SUBJECT: REVISION TO TECHNICAL SPECIFICATIONS - FUEL STORAGE AND
SPENT FUEL STORAGE POOL TEMPERATURE

RE: GRAND GULF NUCLEAR STATION, UNIT 1

Amendment No. 17
License No. NPF-29

SAFETY EVALUATION BY THE OFFICE OF NUCLEAR REACTOR REGULATION
SUPPORTING AMENDMENT NO. 17 TO FACILITY OPERATING LICENSE NO. NPF-29
MISSISSIPPI POWER & LIGHT COMPANY
MIDDLE SOUTH ENERGY, INC.
SOUTH MISSISSIPPI ELECTRIC POWER ASSOCIATION
GRAND GULF NUCLEAR STATION, UNIT 1
DOCKET NO. 50-416

Figure 1. Dynamic Model

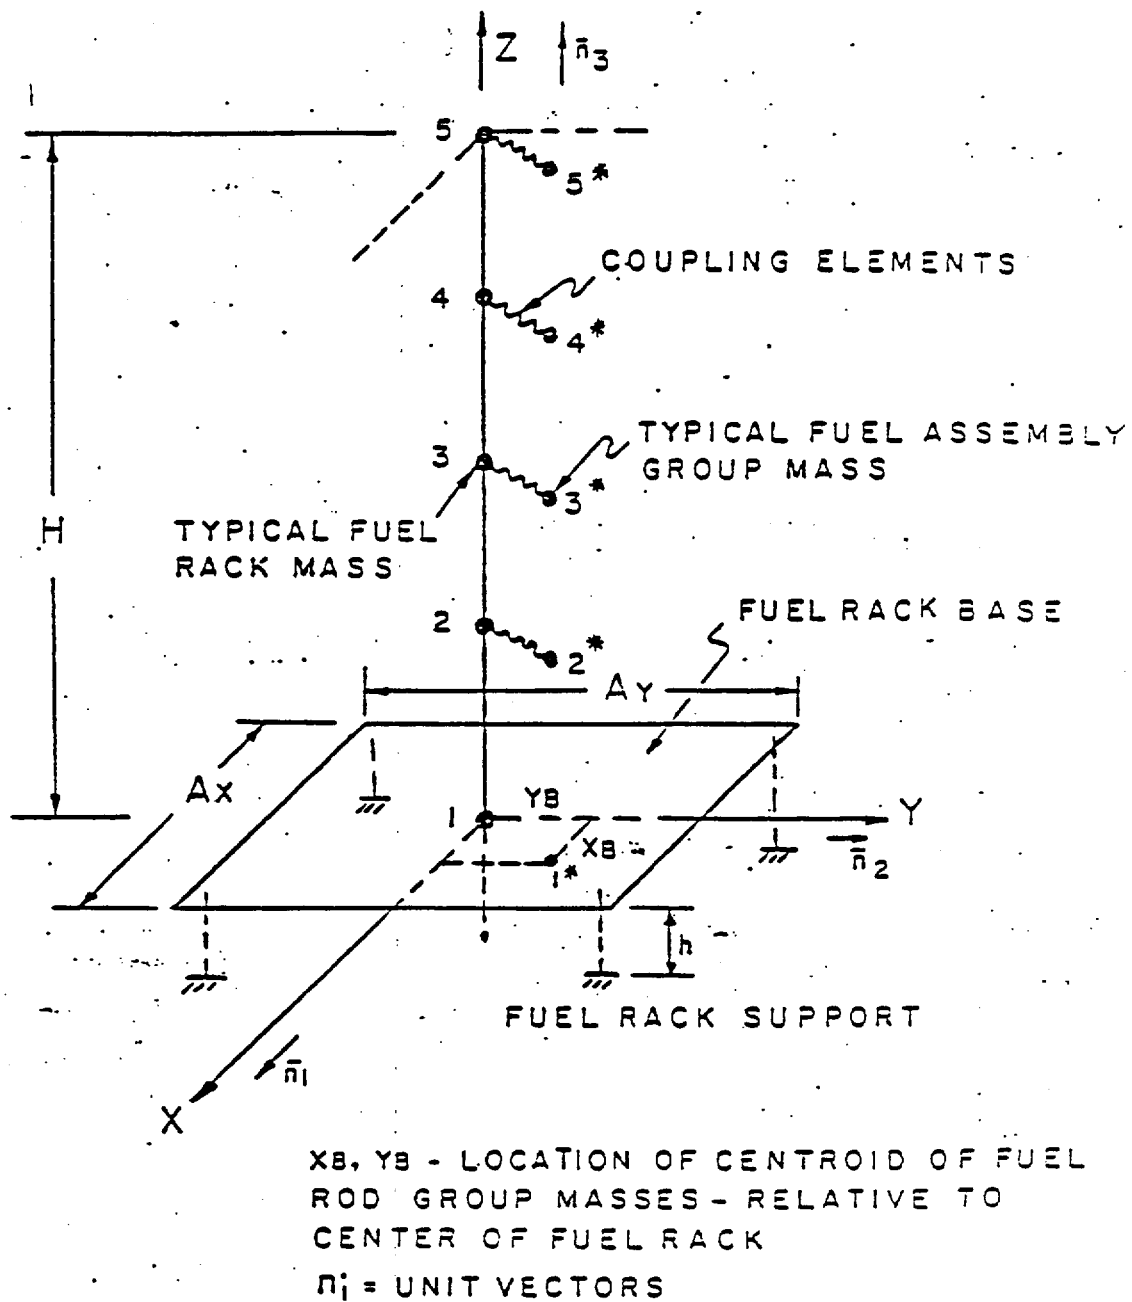
The lumped mass approach was used in the dynamic model, wherein the mass of the fuel rack was lumped at five equidistant locations as shown in Figure 1. For horizontal motion, the rack mass was proportioned at one-quarter of the total mass for each of the three middle mass nodes and at one-eighth of total mass each for the top and the bottom nodes. The mass of the base plate and support structure was lumped with the bottom node. For the fuel assemblies, five lumped masses were used in a similar pattern of distribution. For vertical motion, two-thirds of the racks' dead weight acted at the bottom mass node, with the remaining one-third applied at the top node. All of the dead weight (gravitational force) of the fuel assembly was at the bottom node.

- o The seismic dynamic model considers only the case of fluid coupling to adjacent rack modules wherein the motion of each adjacent module normal to the boundary is assumed to be equal and opposite in its displacement to the module being analyzed. Although this assumption neglects the fact that adjacent fuel rack modules may have quite different dynamic response characteristics, it does provide a very manageable reduction in the analytical modeling of the problem while addressing the case in which the available space for dynamic rack displacement is at a minimum.

Figure 2. Racks' Arrangement in Spent Fuel Pool

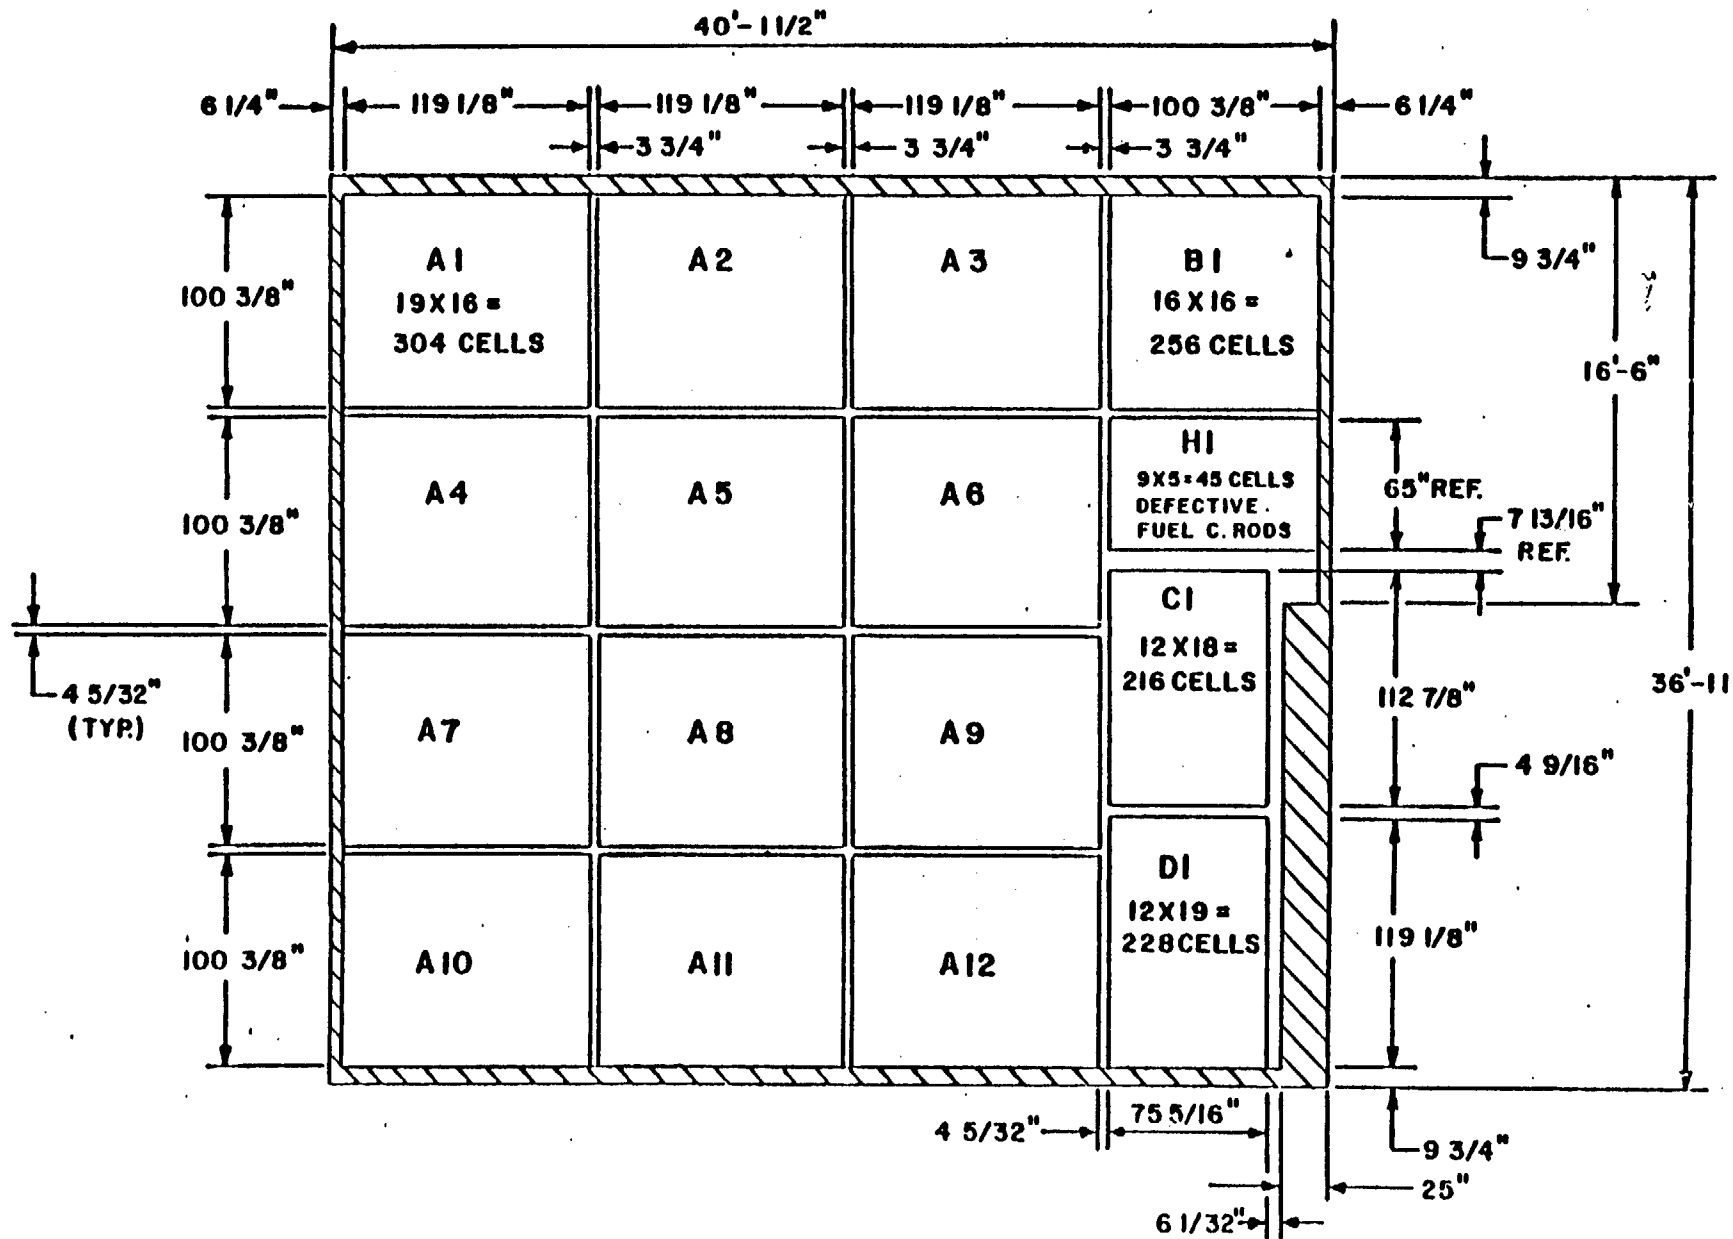
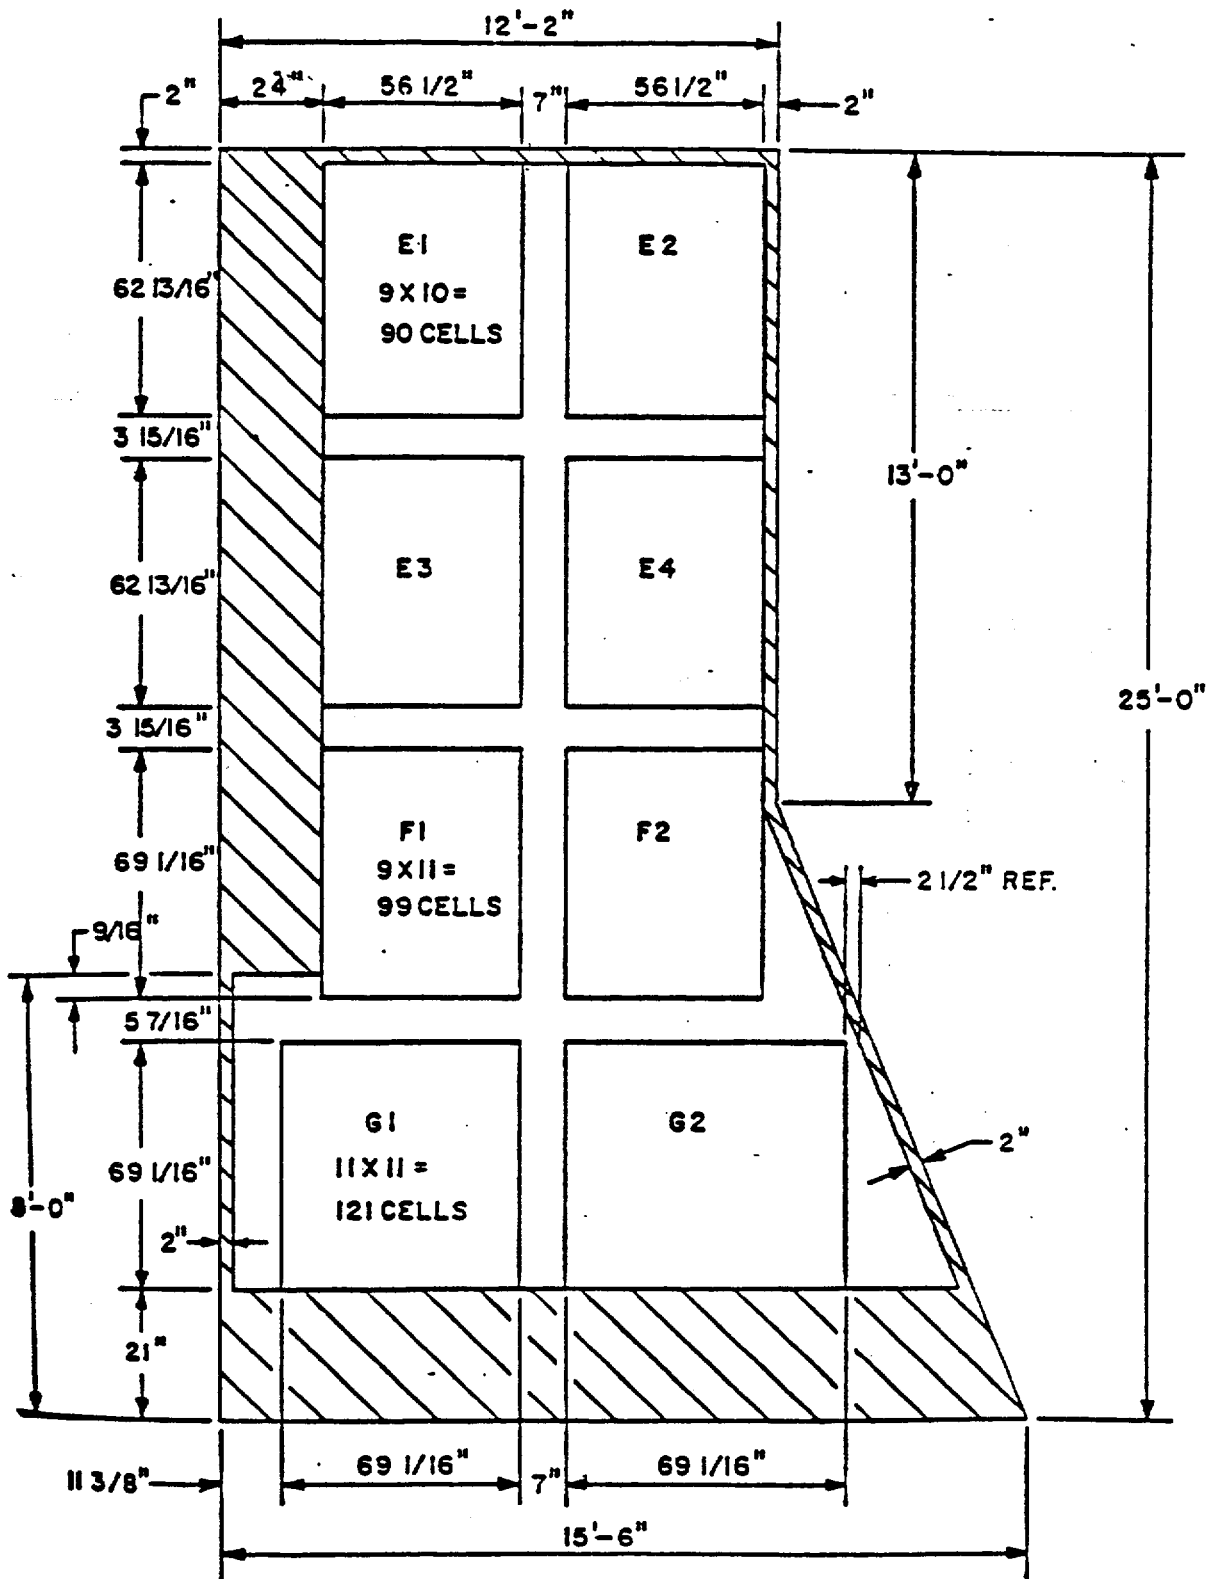
In response to a request for additional information regarding the gap between the racks and the walls, the Licensee [3] confirmed that the shaded areas of Figures 2 and 3 denote the gap between the fuel racks and the pool walls. Thus, clearance is provided between the racks and walls and between adjacent racks.

For the Licensee's mathematical model, the no-collision-of-adjacent-racks criterion generally requires that the maximum rack displacement be smaller than half of the gap between racks. If both adjacent racks are analyzed and out-of-plane rack motion is considered, then the sum of their displacements should be less than the rack clearance. Although it is acceptable to use an average, or equivalent, gap for the purpose of assessing the contribution of fluid action around a fuel module with unequal spacing from other modules, the actual minimum operating gap must be used for comparison with the computed displacements. Although the module may, under the influence of seismic excitation and induced fluid forces, move toward the position of equal gaps from its initial position, repeated collision with adjacent modules could take place before any minimum gap is widened. Thus, comparison of the computed fuel module displacements with the minimum proportioned operating gap is essential.

"The reviewer is correct in stating that out-of-phase motion of neighboring racks is possible. Therefore, it is necessary to model the racks and the associated virtual and coupling hydrodynamic masses assuming a plane of symmetry midway in the gap region. All seismic analyses carried out for Grand Gulf Nuclear Station Unit 1 racks are based on this assumption. The computed maximum rack displacements are

required to be less than 50% of the nominal inter-rack gap. Data presented in Table 6.4 [1] shows that this requirement is met in all cases."

The Licensee's plan for proportioning gaps between racks for comparison with computed rack displacements is satisfactory.
